VIRGINIA ELECTRIC AND POWER COMPANY
RICHMOND, VIRGINIA 23261

VIRGINIA ELECTRIC AND POWER COMPANY
SURRY POWER STATION UNITS 1 AND 2
PROPOSED LICENSE AMENDMENT REQUEST
INCREASED MAXIMUM SERVICE WATER TEMPERATURE LIMIT
REQUEST FOR ADDITIONAL INFORMATION

**LICENSE AMENDMENT REQUEST TO INCREASE
THE MAXIMUM SERVICE WATER TEMPERATURE LIMIT**

RESPONSE TO NRC REQUEST FOR ADDITIONAL INFORMATION

**CCHX OPERABILITY LIMITS
AT 95°F MEASURED SW TEMPERATURE**

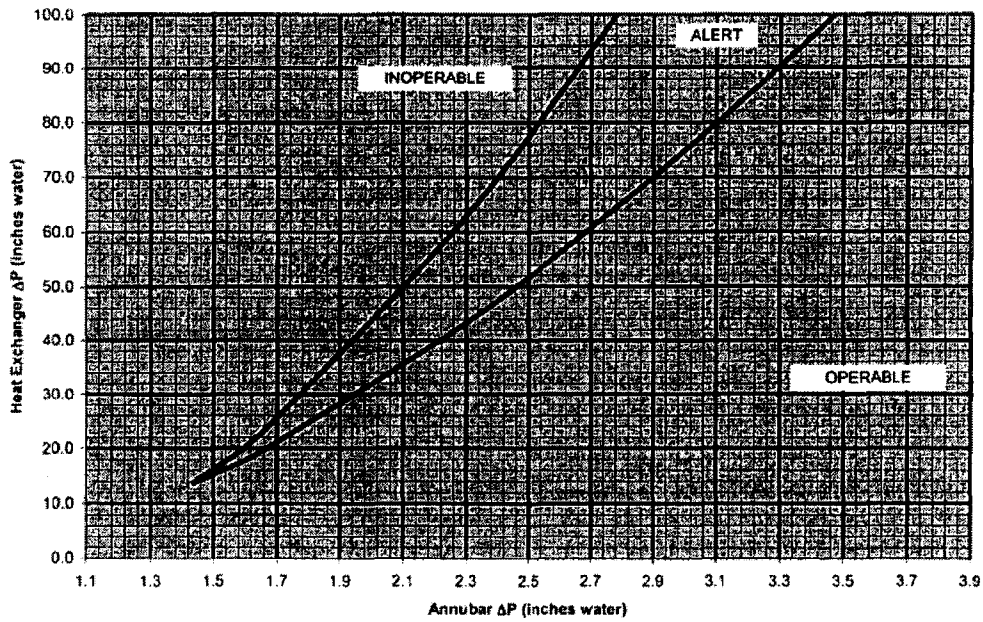
- a. *The only apparent analytical restriction described in the application is limiting the "...CCHX outlet temperature..." to the value used in previous evaluations. What other analytical restrictions have been imposed in the evaluation?*

- b. *In constraining the CCHX outlet temperature to the same values as in previous evaluations, describe any changes in the way the CC or SW systems are operated or maintained?*

A calculation was performed to develop curves to show the operable limits for the service water flow expected during normal plant operation. The curves identify an operable range for each heat exchanger. This indicates that the heat exchanger is capable of removing the necessary heat load for a given service water flow. The curves also identify an alert condition for a heat exchanger. This indicates that the heat exchanger is capable of removing the required heat, but consideration must be given to heat exchanger cleaning. The inoperable region of the curves identifies that the heat exchanger has degraded below the minimum capability to remove the required heat load.

Two such curves are presented in the two figures provided below for CCHX operability at SW temperatures of 95°F and 100°F, respectively. The x-axis of the chart represents the annubar differential pressure that measures the total SW flow through the CCHX. The y-axis of the chart represents the tubesheet differential pressure that indicates the pressure drop across the tubesheet. The line designating the area of CCHX inoperability for a specific SW temperature was developed by determining the extent of tube plugging (i.e., tubesheet differential pressure) at various SW total flow values, while holding the heat load constant, beyond which the CCHXs could not adequately perform their heat removal function. For a constant heat load, as SW temperature drops, required SW flow can be reduced.

As indicated in the two figures below, the operability limit curves are temperature sensitive. Therefore, operability limit curves have been developed for the CCHXs for SW temperatures ranging from 60°F to 100°F in five degree increments. The operability limit curves will be incorporated into station CCHX surveillance tests to verify the ability of the CCHXs to adequately perform their required safety function at various SW temperatures.
